# Proposal on PN overhead reduction in AES-CCM

Document Number: C80216m-09/0177r1

IEEE 802.16m-08/052 - Call for Comments and Contributions on Project 802.16m SDD  
Topic: Security, AES CCM Mode sub section 10.6.5.1.1

**Figure 1. Proposed Encrypted Payload Format in AES CCM Mode**

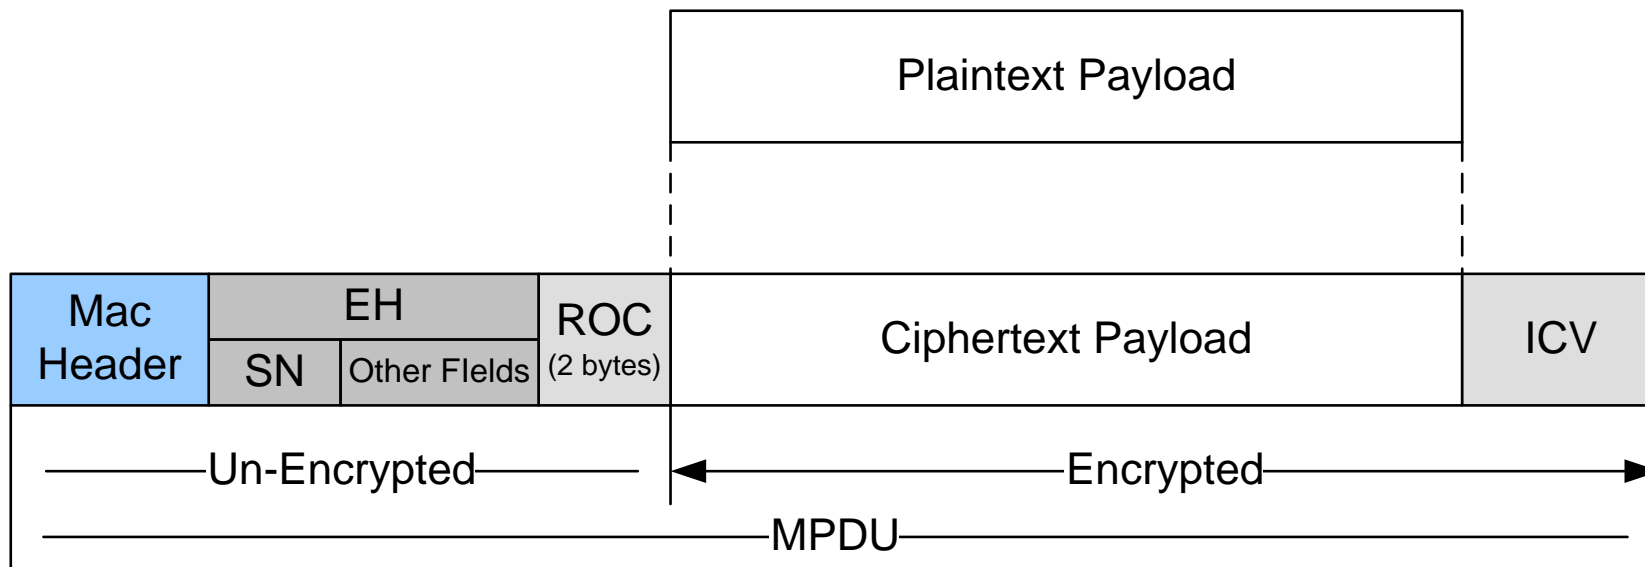
- Problem - How to share the information in initial CCM block between MS and BS when AES-CCM is used for data encryption?
  - In 16e, PN(4byte),GMH & length of plaintext payload are parameters present in initial CCM block
  - PN is explicitly included in encrypted MPDU for decrypting cipher text
  - **ISSUE : To reduce the encryption (4 byte PN) overhead**
- Motivation - Sequence number (SN) per flow (e.g. ARQ\_SN or FSN) is present in each MPDU
  - The SN increments by 1 per MPDU
- Define a ROC (roll-over counter; 2bytes) of the SN
  - ROC is included in the MPDU format explicitly
    - Encryption overhead : ROC+ICV = 2+8 bytes
    - EKS could be included as 2bits of ROC (e.g. 2bits EKS +14bits ROC)
  - SN and ROC are used as input values of initial CCM block.
  - SN & ROC in a MPDU are not encrypted

- ROC maintained per flow
  - The ROC is the rollover counter for the SN
    - When the SN is changed from its Max to 0, the ROC is incremented by 1.
    - Sequence number (e.g. ARQ\_SN or FSN) is not applied at a MPDU, ROC is incremented at each PDU.
  - Before the ROC of a Flow overflows, the TEK of the SA to which this flow is mapped is updated
  - If TEK is updated, then the flows mapped to the related SA reset their ROC by 0.

Figure xx. Proposed Encrypted Payload Format in AES CCM Mode

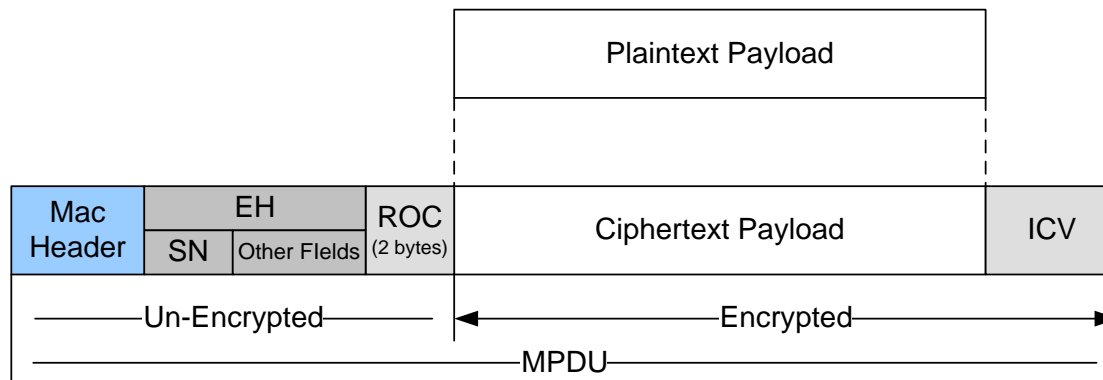
~~The PN size is reduced in 802.16m from 4 bytes to 3 bytes. Further reduction in PN and supporting methods are FFS~~

For encryption of MPDU based on AES in CCM mode, ROC and Sequence Number of PDU(if present) is used as input values for nonce and ROC is appended at MAC PDU format.

ROC is maintained per flow.

When the Sequence number is rolled over, the ROC is incremented.

If Sequence number is not applied at a PDU, ROC is incremented at each PDU.

The MS shall ensure that a new TEK is requested and transferred before ROC overflows. If ROC overflows without new keys being installed, transport communications on that SA shall be halted until new TEKs are installed. If the TEK is updated, then the flows mapped to the related SA reset their ROC by 0. Any tuple value of {Flow ID, ROC, Sequence number , TEK} shall not be used more than once for the purposes of transmitting data.
